Winnebago Industries[®] submits the following report pursuant to Part 573 of the NHTSA regulations. The numbered paragraphs below correspond to those found at Part 573.5(c).

Re: Defect Information Report FL-501, AAC axle Steering Arm Bolts

**Recall Notification
Subject: AAC Front Axle Tie Rod and Steering Arm Fasteners**

December 2007
 FL501A
 NHTSA #07V-306

Fig. 1, Steering Arm and Tie Rod Arm

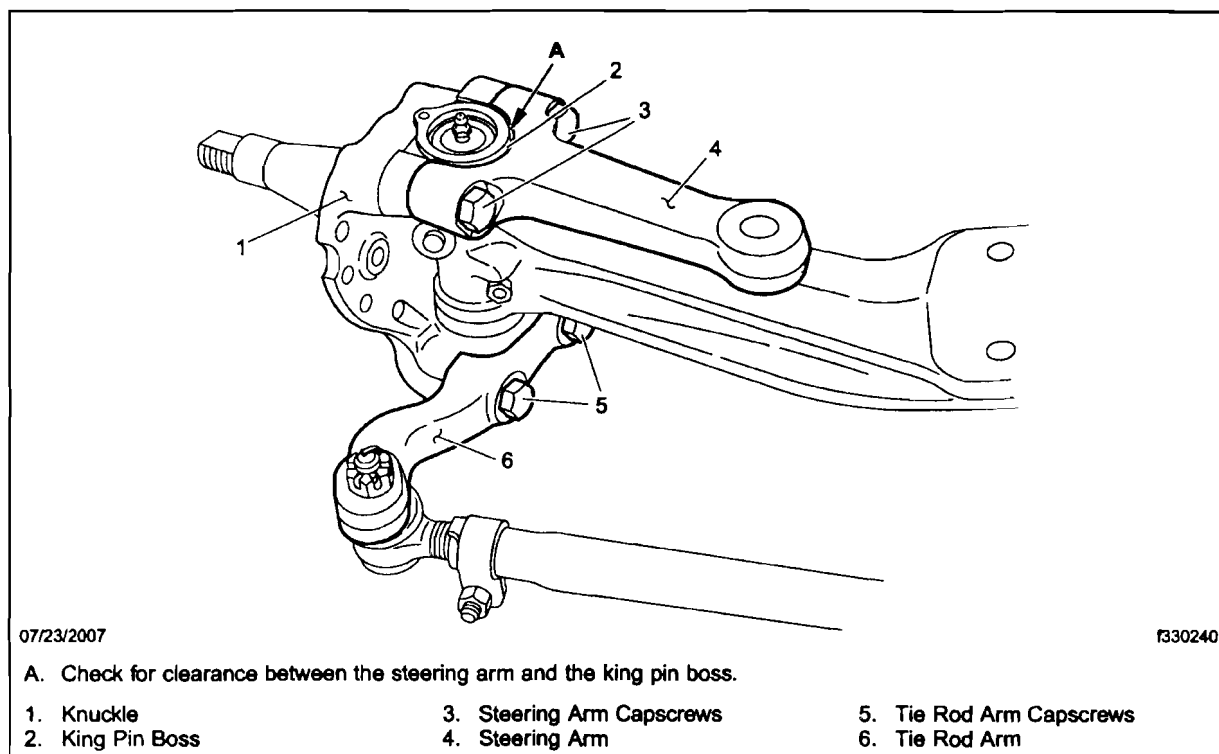
During front axle assembly, the fasteners that attach the steering arm or the tie rod arms to the spindle may have been over or under tightened. Incorrectly tightened fasteners may fatigue and fracture, resulting in a possible vehicle crash without prior warning.

1. Check the base label (Form WAR259) for a completion sticker for FL501 (WAR260) indicating this work has been done. The base label is usually located on the passenger-side door about 12 inches (30 cm) below the door latch on trucks, over the driver's window in school buses, on the front wall under the dash in motorhomes, or in the driver's area in step vans. If a completion sticker for FL501 is present, nothing more needs to be done. If no sticker is present, go to the next step.
2. Shut down the engine, and chock the front tires.
3. Using a 0.004 inch (0.1 mm) feeler gauge, check the clearance between the steering arm and the king pin boss. See Fig. 1.

1. Remove one of the capscrews that attaches the steering arm to the steering knuckle. See Fig. 1.
2. Check the capscrew threads to verify whether Loctite® or another thread locking compound was applied to them.

1. Remove one of the capscrews that attaches the tie rod arm to the knuckle. See Fig. 1.
2. Check the capscrew threads to verify whether Loctite® or another thread locking compound was applied to them.

3. Apply Loctite 277 to the threads of a new M20 x 1.5 x 80 capscrew from the Recall kit.
4. Install the new steering arm capscrew and tighten it 425 lbf-ft (575 N-m).
5. Repeat steps 1 through 4 to replace the second capscrew.
6. Continue with the "Tie Rod Arm Capscrew Replacement" procedure in these Work Instructions.

3. Apply Loctite 277 to the threads of two new M20 x 1.5 x 80 capscrews.
4. Install a new steering arm with its engraved part number facing upward.
5. Install the new steering arm capscrews and tighten them 425 lbf-ft (575 N·m).
6. Go to the "Tie Rod Arm Capscrew Replacement" procedure in these Work Instructions.
